**RE: Lot 6 Block 4 Unit 18, S.A.D. 228
Volcano Cliffs Subdivision
6600 Papagayo Rd NW
Grading and Drainage Plan
Engineers Stamp Date 1/2/18 (D10D003J6)
Pad Certification Date 1/19/18**

RE: **Lot 6 Block 4 Unit 18, S.A.D. 228**
Volcano Cliffs Subdivision
6600 Papagayo Rd NW
Grading and Drainage Plan
Engineers Stamp Date 1/2/18 (D10D003J6)

CITY OF ALBUQUERQUE, BERNALILLO COUNTY		NEW MEXICO	
LOT 6, BLOCK 4, UNIT 18 VOLCANO CLIFFS SUBDIVISION			
PECK (BUILDER: MICHAEL SANCHEZ) — GRADING & DRAINAGE PLAN			
McDowell Engineering, Inc.			
7820 BEVERLY HILLS AVE. NE • ALBUQUERQUE, NM 87122			
TELE: 505-828-2430 • FAX: 505-821-4857			
Designed JSM	Drawn STAFF	Checked JSM	Sheet of
File PEC0117L	Date DECEMBER, 2017	1	1

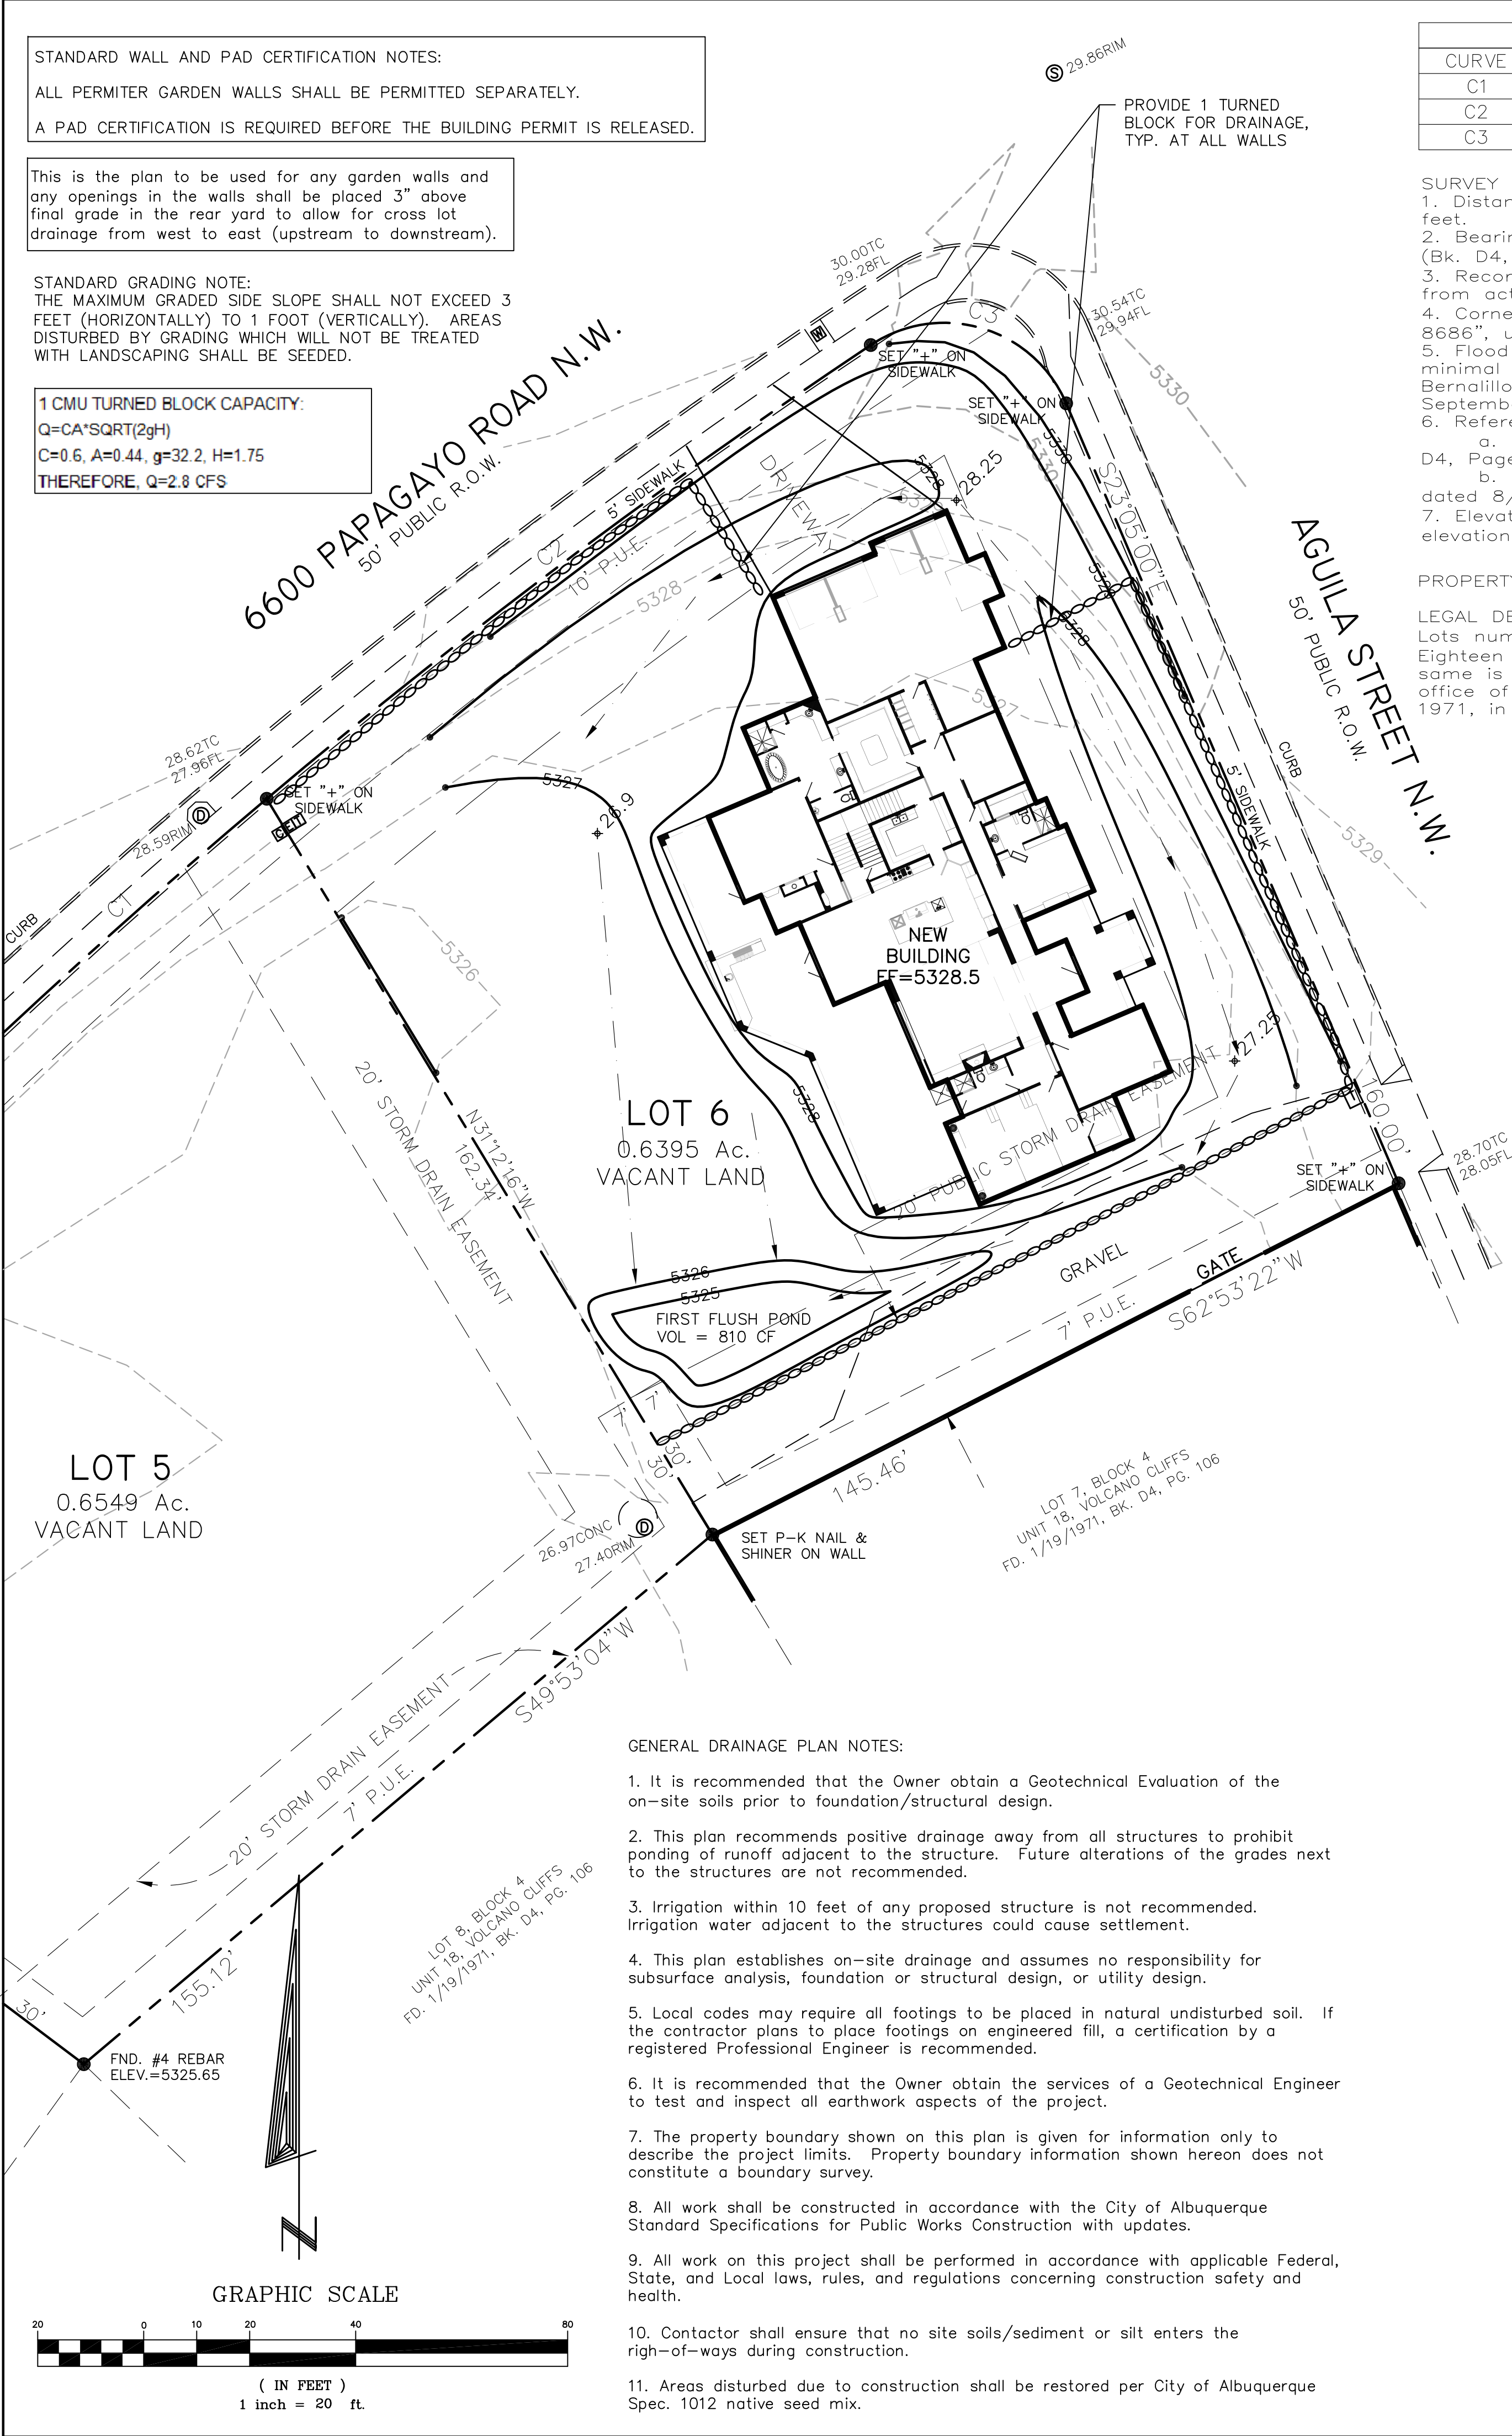
Reiterate to the Owner/Contractor that a separate permit for a garden/retaining wall must be obtained, with the approved G&D plan dated 1/2/18.

Prior to Building permit approval a Pad Certification will be required, provided by the Engineer or a registered Land Surveyor.

Reiterate to the Owner/Contractor that a separate permit for a garden/retaining wall must be obtained, with the approved G&D plan dated 1/2/18.

This is the plan to be used for any garden walls and any openings in the walls shall be placed 3" above final grade in the rear yard to allow for cross lot drainage from west to east (upstream to downstream).
